6773B County Permit Review Worksheet

IMPROVEMENT PERMIT for a RESIDENTIAL ON-SITE WASTEWATER TREATMENT & DISPOSAL SYSTEM

GWS Septic System Design Review

RE: Request for an Improvement Permit for Lot 35 at The Retreat at Latta Plantation off of Sample Road.
MCHD File #6773B

Scale: 1 inch equals 50 feet	S&ME	Faison-Sample Road, LLC	FIGURE
Drawn by: JBP		Lot 35	1
Reviewed by: Jeremy P. Michelone, RS		Mecklenburg County, NC	
Date: March, 2007	ENVIRONMENTAL SERVICES • ENGINEERING • TESTING	S&ME Project #1588-05-091

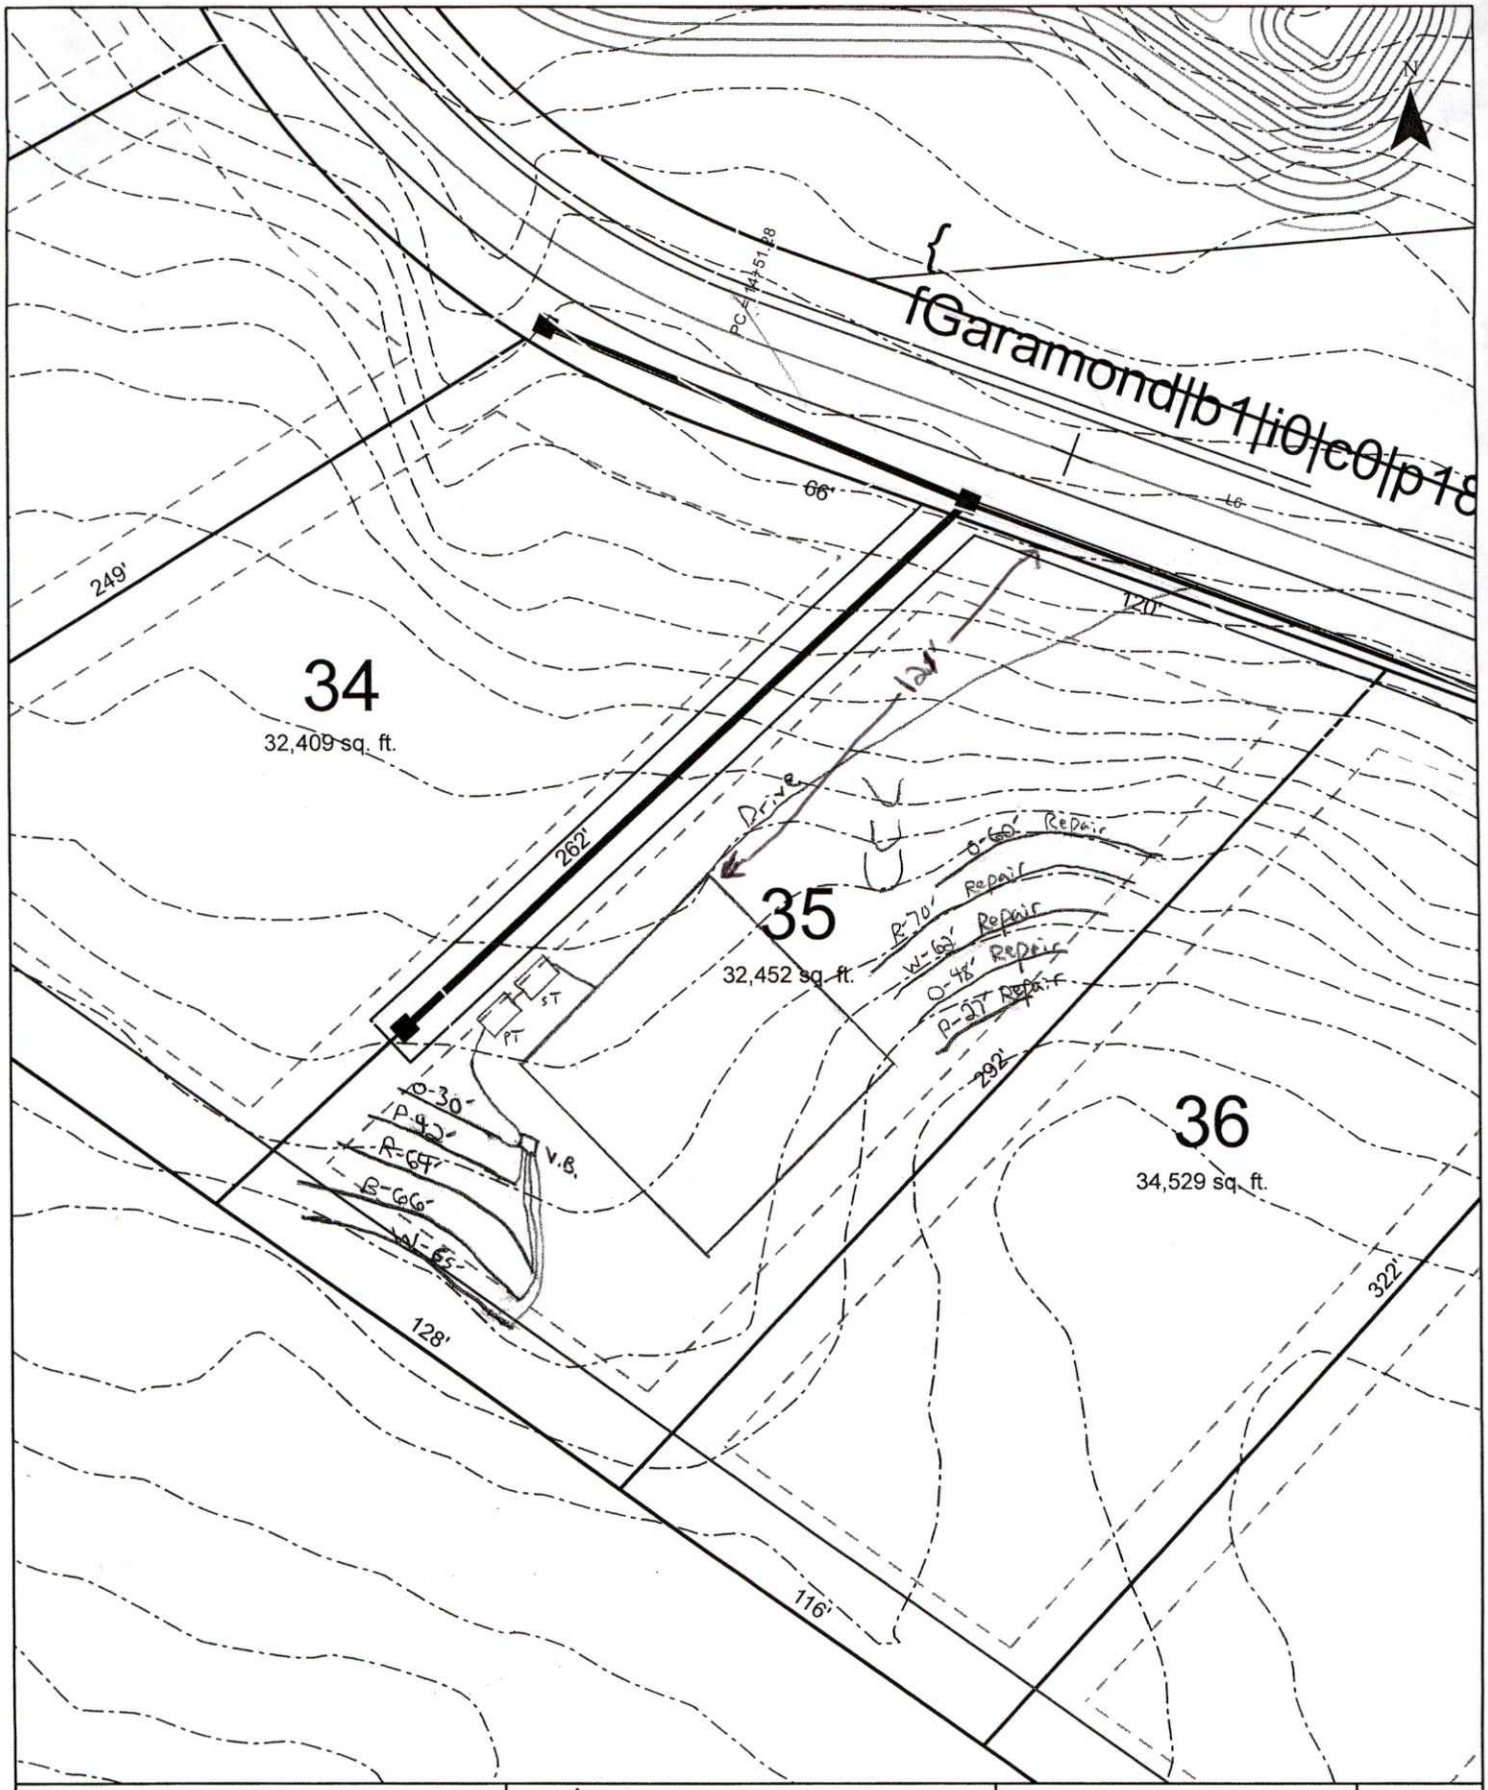
1. Install system using 3 ft. wide trenches.
3. System design requires effluent pump for distribution.
4. 100% Repair area is required.
